**LSE Libra LLC (Lodestar Energy)
petition for a declaratory ruling, pursuant
to Connecticut General Statutes §4-176
and §16-50k, for the proposed
construction, maintenance and operation
of a 1.5-megawatt solar photovoltaic
electric generating facility located at 410
Denslow Hill Road in Hamden,
Connecticut, and associated electrical
interconnection.**

PETITION NO. 1627

PETITIONERS' RESPONSES TO COUNCIL'S INTERROGATORIES

Exhibit 1

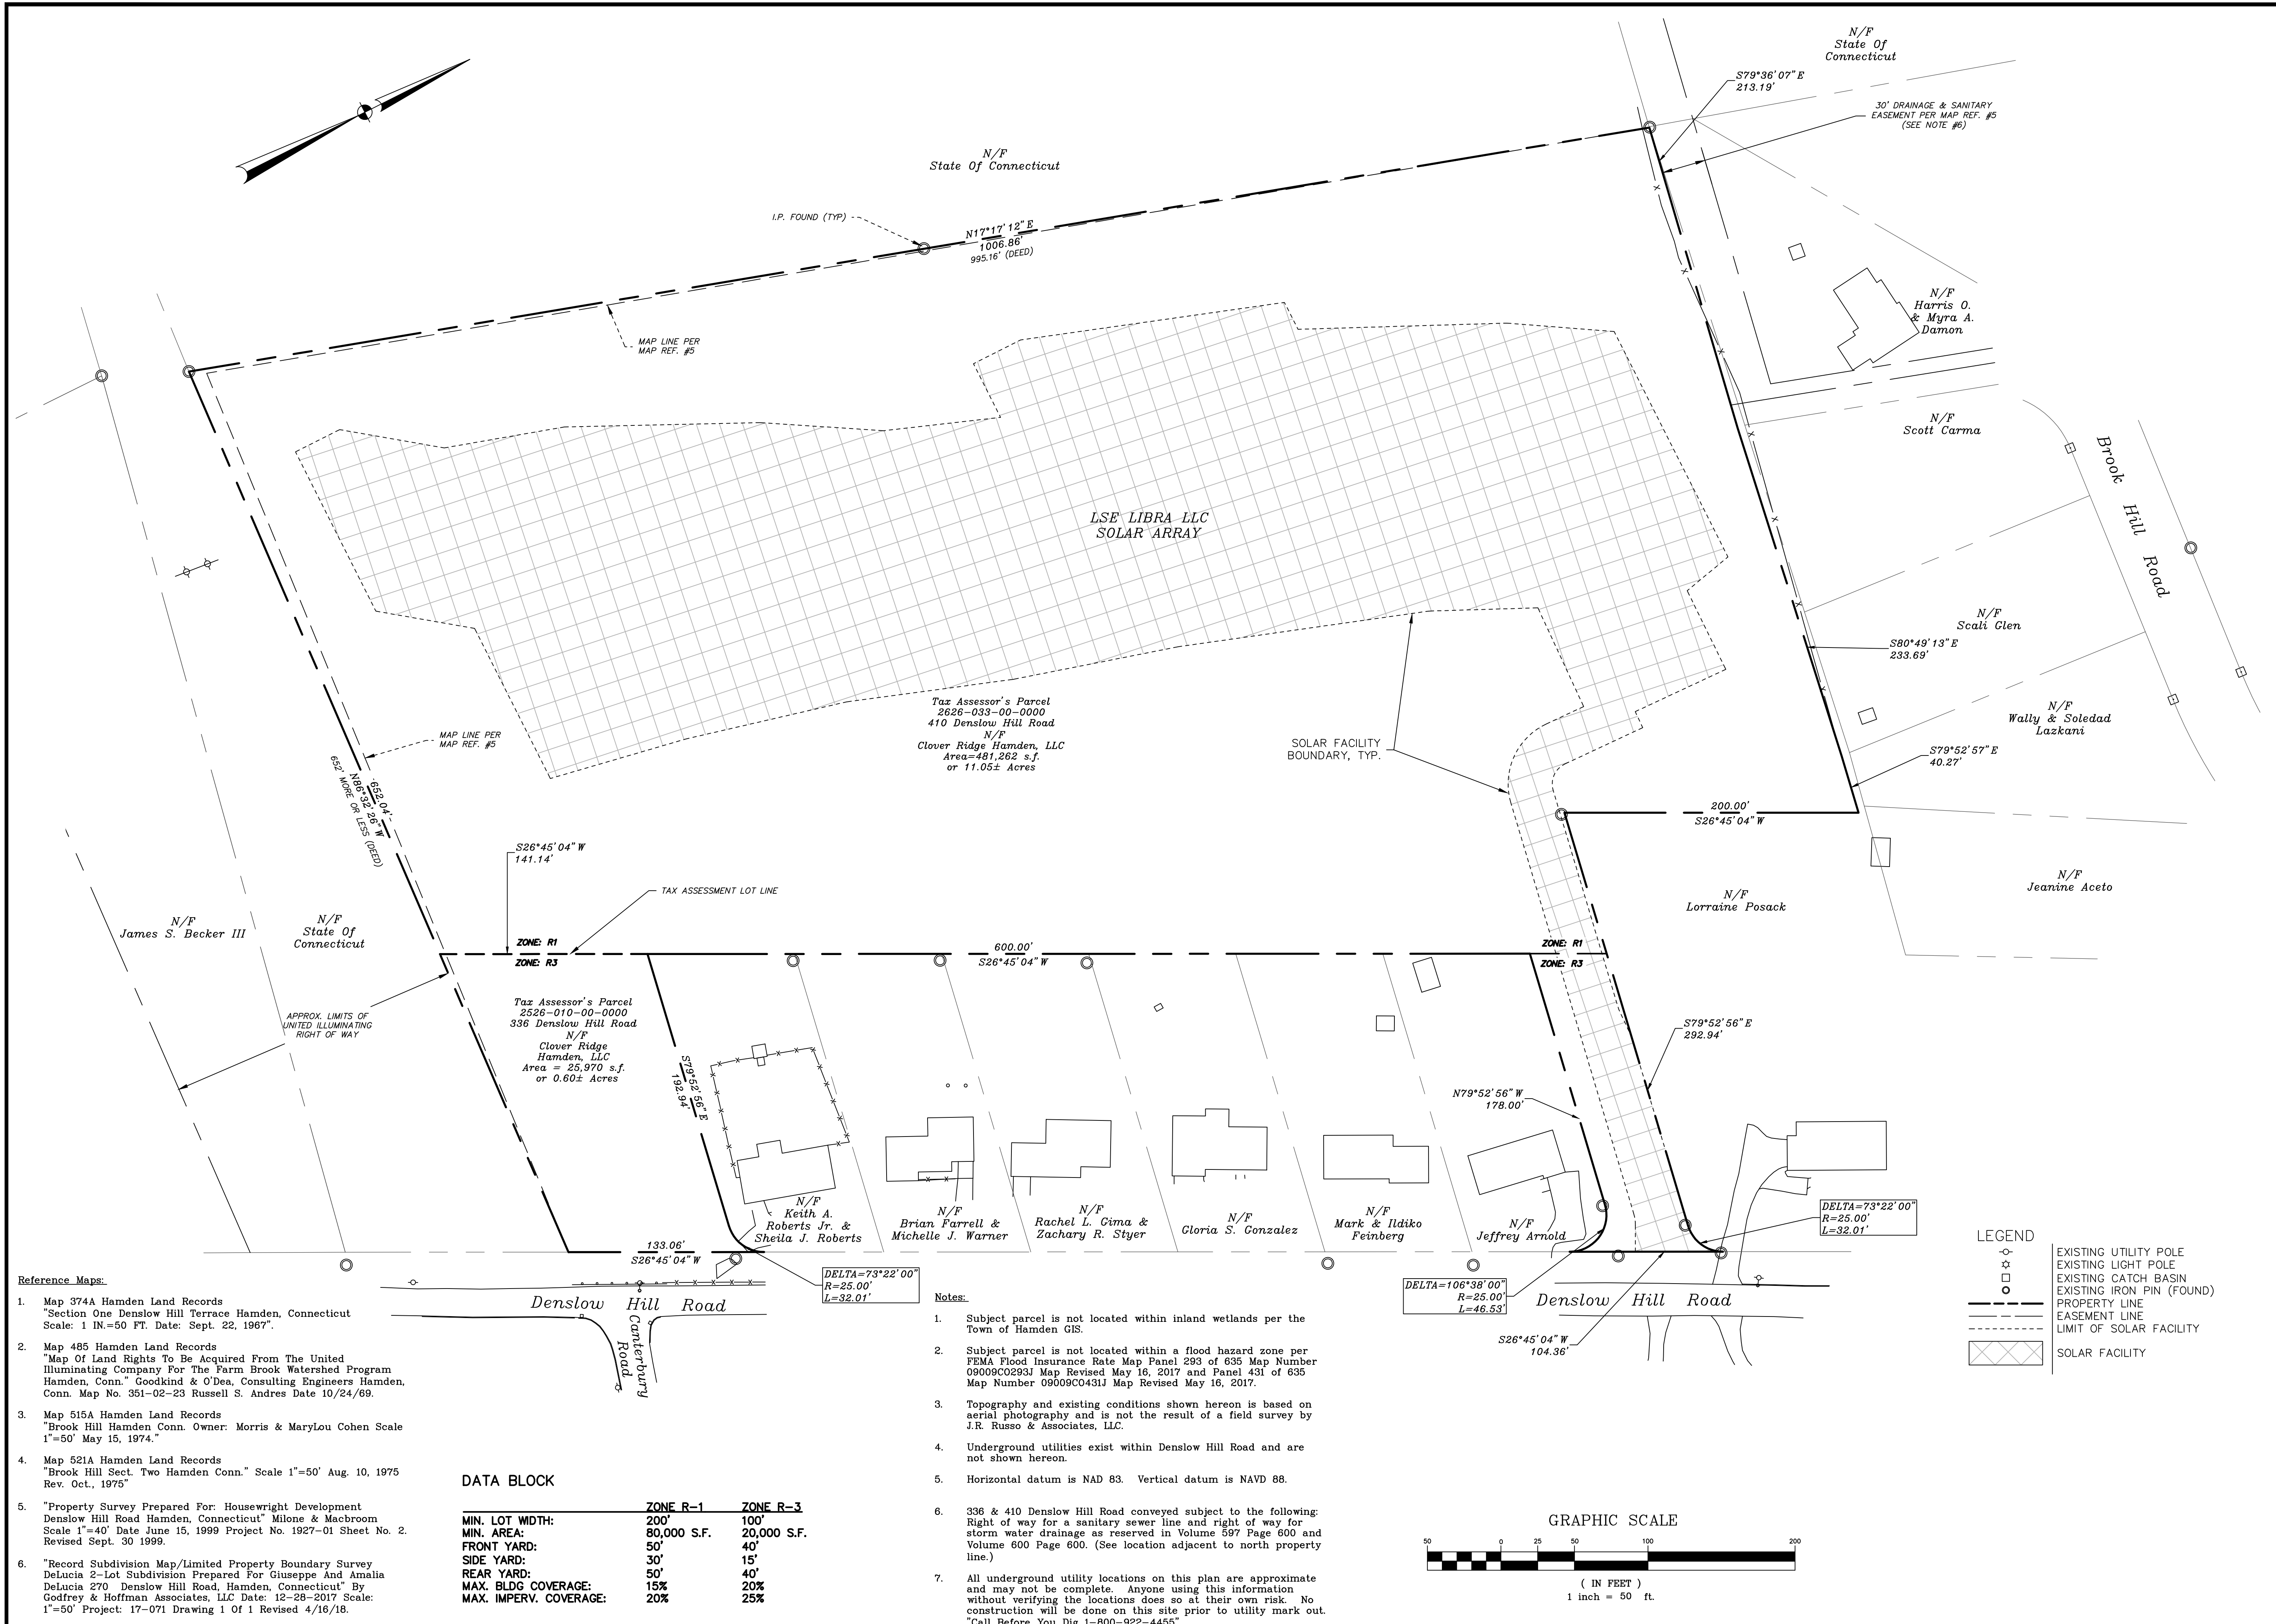
11. Submit a map clearly depicting the boundaries of the solar facility site and the boundaries of the host parcel(s). Under Regulations of Connecticut State Agencies (RCSA) §16-50j-2a(29), "Site" means a contiguous parcel of property with specified boundaries, including, but not limited to, the leased area, right-of-way, access and easements on which a facility and associated equipment is located, shall be located or is proposed to be located.

RESPONSE: See Exhibit 1 attached.
